From: Christopher Ryder
Sent: Monday, April 30, 2007 11:46 AM
To: Albert Wong
Cc: Andy Campbell; Robert Johnson (NMSS); Sheena Whaley
Subject: Revised Descriptions of the HVAC and Electrical Systems
Attachments: Electrical System.wpd; HVAC system.wpd

Per your request, I have revised the description of the HVAC and electrical systems to address comments from Region IV.

Figure 1. Simplified electrical diagram. LEGEND: NC: normally closed switch. NO: normally open switch. S&C: sense and command.

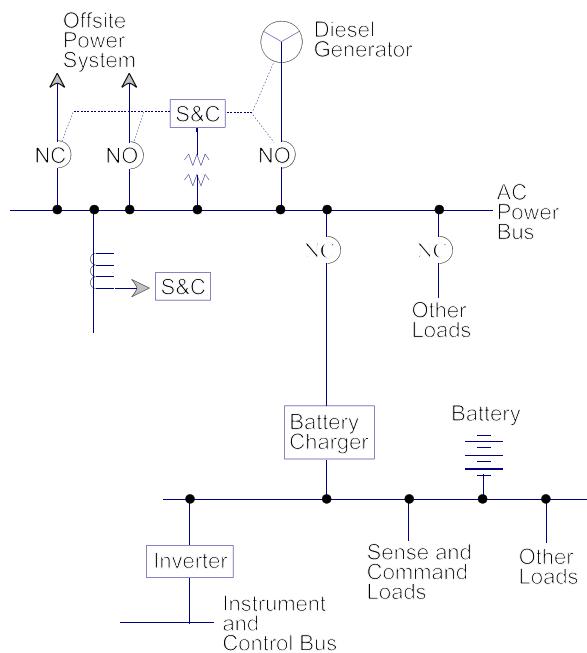
Comment: "I don't see anything in this operation that would require a quick restoration of power. I recommend manual diesel generator startup, warmup and loading. It is much easier on the engine and far less costly."

Reply: I agree that the operation does not require an immediate restoration of power. I am merely stating what DOE has said. Also, auto start is not necessarily synonymous with "crash" start as is done at the power plants. At the plants, the start up of the diesel generators is based on a design basis LOCA. The diesel generators must start and come up to speed, and then have select loads sequences back onto line to meet the design basis. I have heard no information about the design basis of the GROA. I would expect the start up requirements to be much less stringent. Still, the diesel generators could be automatically started. I studied this in 1981 and gave a presentation to an ACRS subcommittee. Revision: Added some words to this effect.

Figure 1. HVAC System

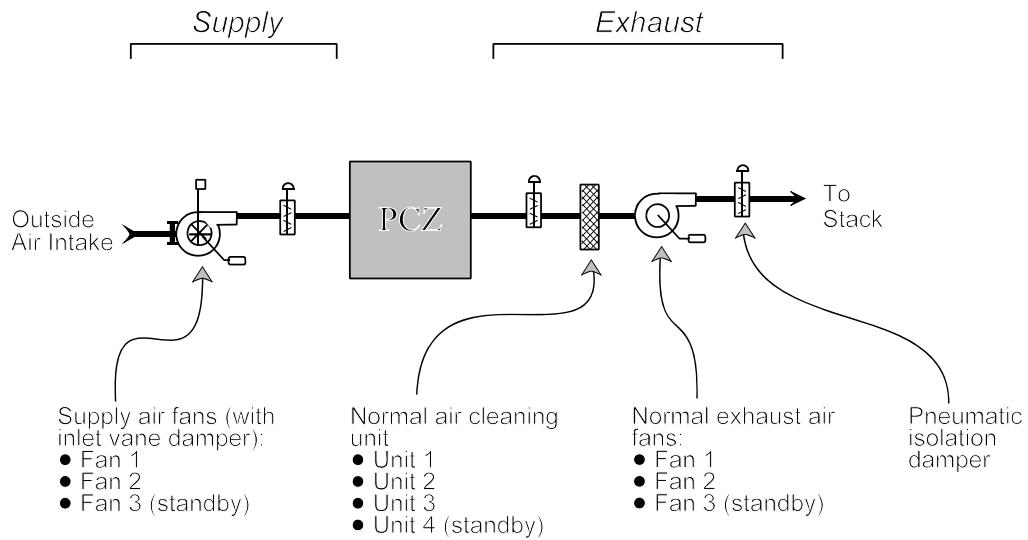
Comment: Regarding the HVAC system, "I recommend a dual (parallel) filter system such that one filter at a time can be changed without shutting down the fans."

Reply: I do not know enough about this to say how the remote filter will be configured. The preliminary design that I saw about three years ago in a public document did not have parallel trains on the remote filter. But there may not be a remote filter on the current design. The previous design was when fuel would be transferred in a dry environment. The current design, in the pool, is much cleaner. In a BWR, filter back consists of the following units:

Revision: From my perspective, there is no need for a remote filter, hence, I removed it from my description. The text states that there are two HEPA filters present. I did not distinguish between the HEPA filters and the prefilter.
